WIRELESS STATION A510

TECHNICAL HANDBOOK - MODIFICATION INSTRUCTION

Receiver netting

Increasing keying speed

Fig 1 - Underside view of receiver chassis

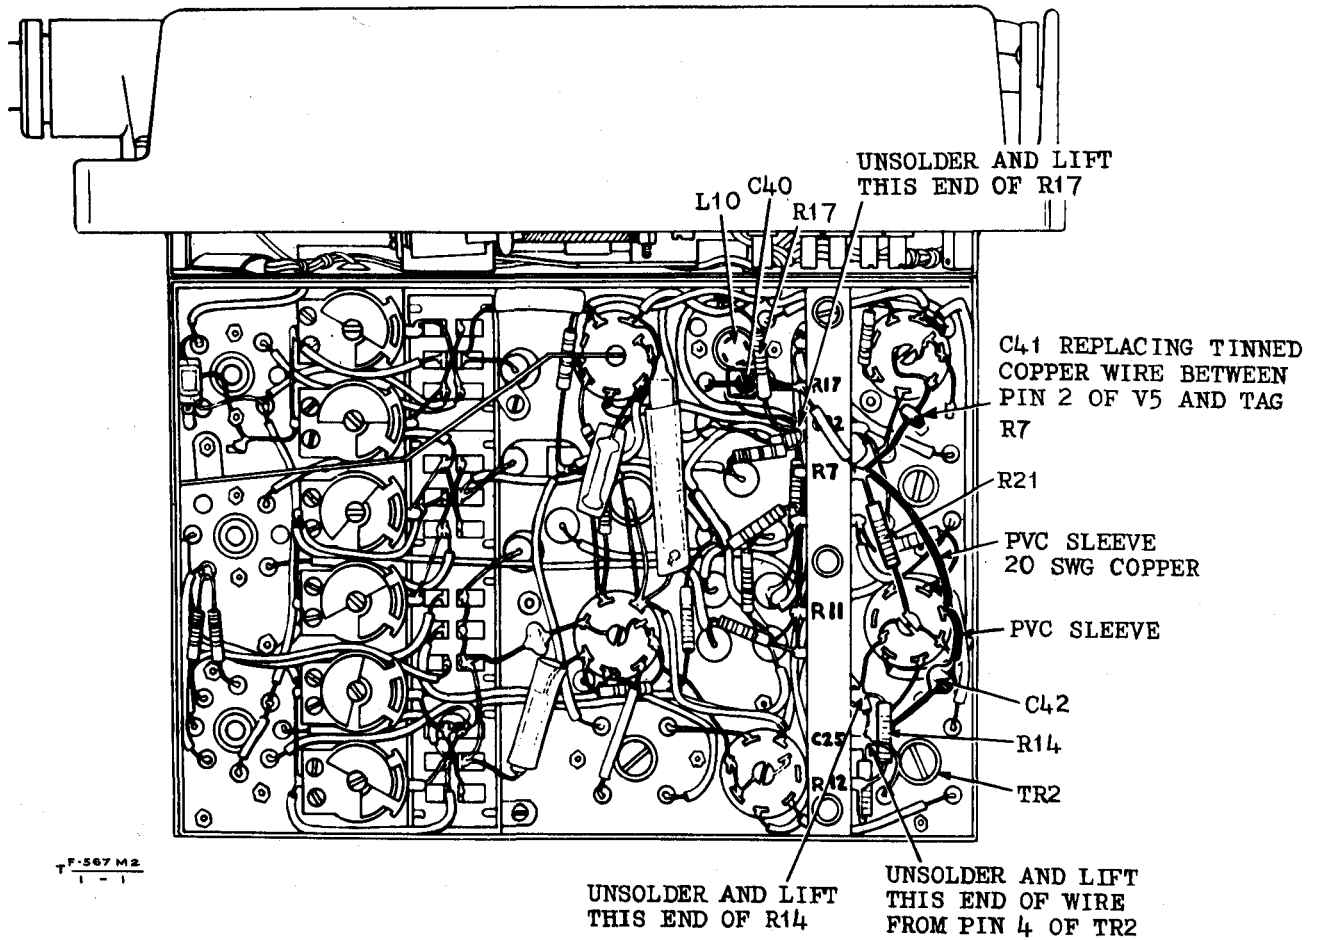
- (b) Locate resistor R17 ($47k\Omega$ $1/2W$) and unsolder and lift that end of it which is connected to the tag marked 'C32'.
- (c) Cover the body of one of the Capacitors, Z/ZA 1756 supplied, with $3/8$ in. of 10 mm P.V.C. sleeving and solder this capacitor between pin 1 (green spot) of the inductor L10 and the tag marked 'R17'. This capacitor becomes 'C40'.

- (d) Solder the floating end of R17 (disconnected at (b)) back on to the tag marked 'C32'.
- (e) Unsolder and remove the wire lead connecting pin 2 of V5 to the tag marked 'R7'.

- (f) Solder the other Capacitor Z/ZA 1756 in circuit between the two points from which the wire was removed at 7(e), ie between pin 2 of V5 and the tag marked 'R7'. This capacitor becomes 'C41'.

- (g) Solder the resistor Z/Z 222130, supplied, between the tag marked 'R7' and the centre spigot of the valve holder V4. This resistor becomes 'R21'.
- (h) Connect the tag marked 'R7' to pin 4 of the valve holder V4 using 20 s.w.g. tinned copper wire insulated by $1.1/2$ mm yellow P.V.C. sleeving.

- (j) Unsolder and lift the wire lead which connects at the tag marked 'C25' (This lead joins tag 'C25' and pin 4 of the second i.f. transformer, TR2). Also, unsolder and lift the earth end of resistor R14.

- (k) Connect the Capacitor Z/AZ 1761, $4.7pF$, supplied, between pin 4 of the valve-holder V4 (covering this lead of the capacitor with $1.1/2$ mm yellow P.V.C. sleeving) and pin 1 (red spot) of TR2. This capacitor becomes 'C42'.

Fig 1 - Location of C109

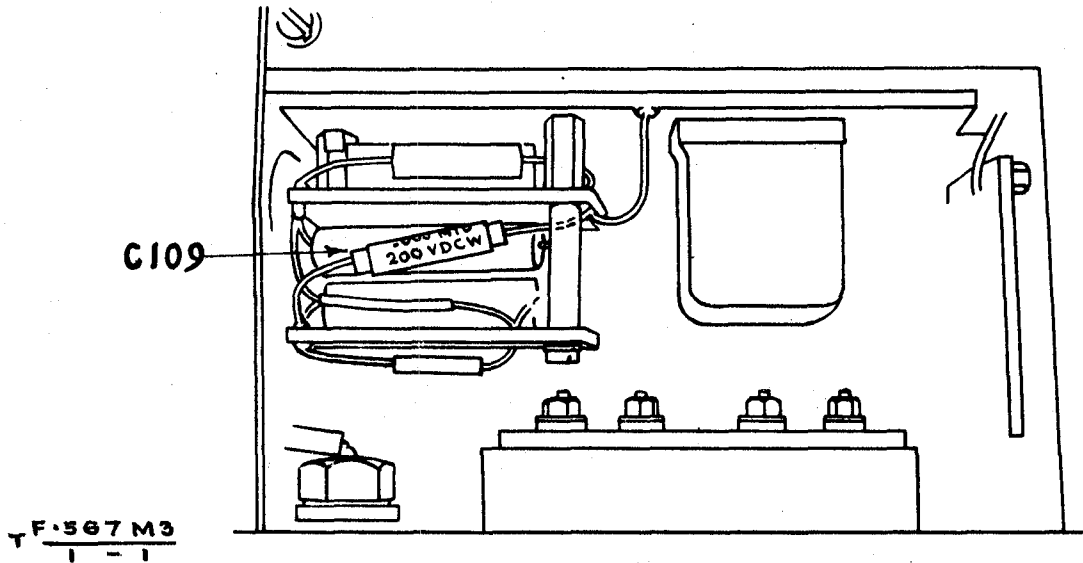
- (b) Locate capacitor C109 (0.001 μ F) (see Fig 1).
- (c) Replace C109 by one of the 0.005 μ F capacitors (Z/Z 115626) provided, connecting one end of the new capacitor to the earth point directly below the spacing pillar and the other end to the top tag diagonally opposite to this earth point. Discard the 0.001 μ F capacitor.

Fig 2 - Location of C111 and C127

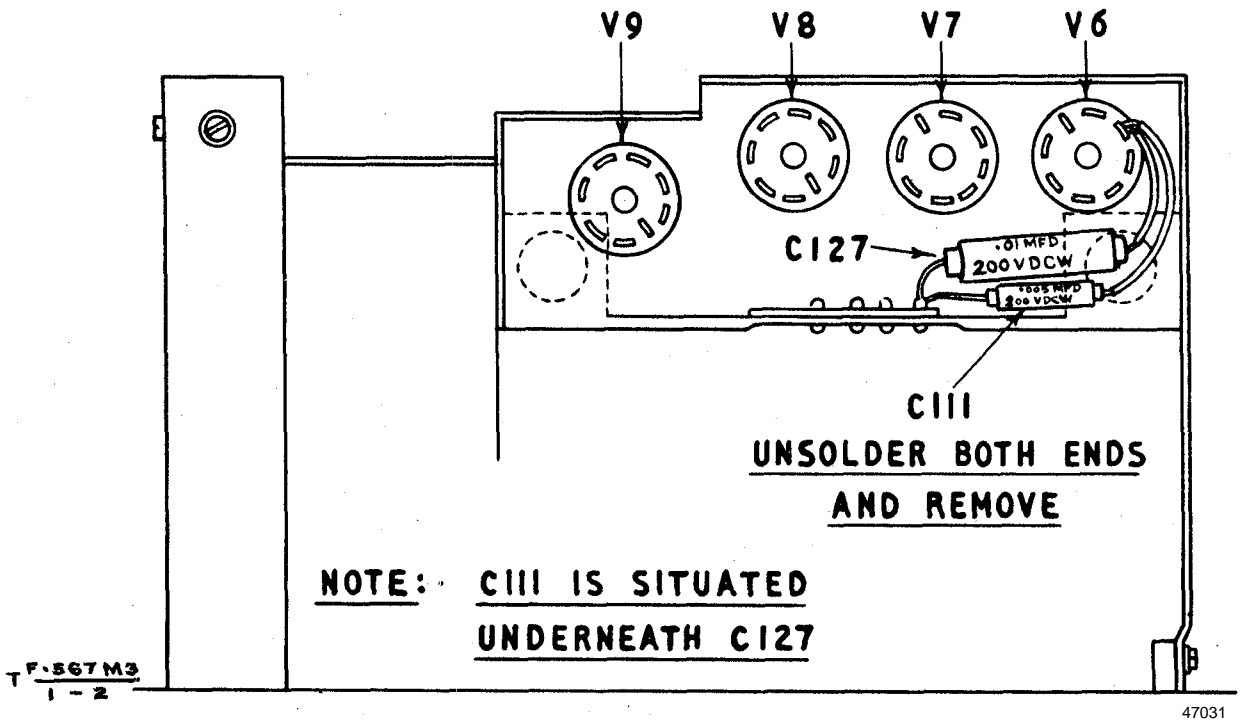
- (d) Locate and remove capacitor C111 (0.005 μ F), which is connected between pin 2 of the valve holder V6 and the terminal plate, and lies underneath capacitor C127 (0.01 μ F) (see Fig 2). Discard the capacitor.

Fig 3 - Capacitor C129 in position

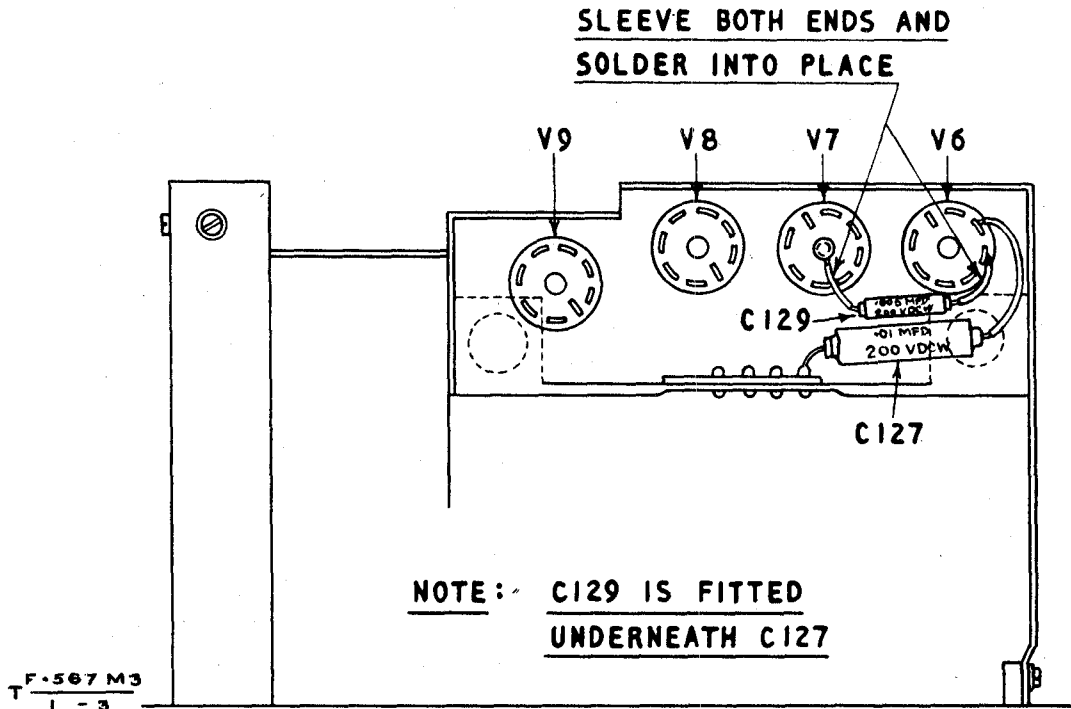
- (e) Place the other capacitor Z/Z 115626 supplied, into the space vacated by C111 and connect it between pin 3 of the valve holder V6 and the earthed spigot of the valve holder V7, after cutting each of the leads of the new capacitor to a suitable length and insulating it with 1.1/2 mm yellow sleeving. This new capacitor becomes 'C129' (see Fig 3).

Fig 4 - Resistor R117 in position

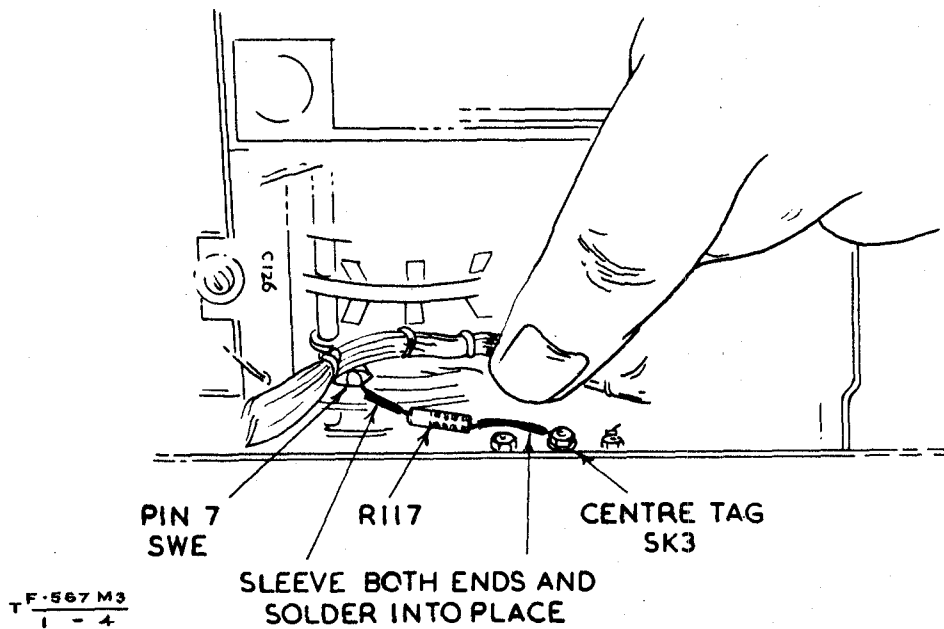
- (f) Referring to Fig 4, locate and remove the lead which joins the centre tag of the 3-point key socket SK3 to pin 7 of the switch SWE. Solder the resistor (220k Ω , Z/Z 223079) supplied, between the same two points ie so that it takes the place of the lead removed. The new resistor becomes R117.
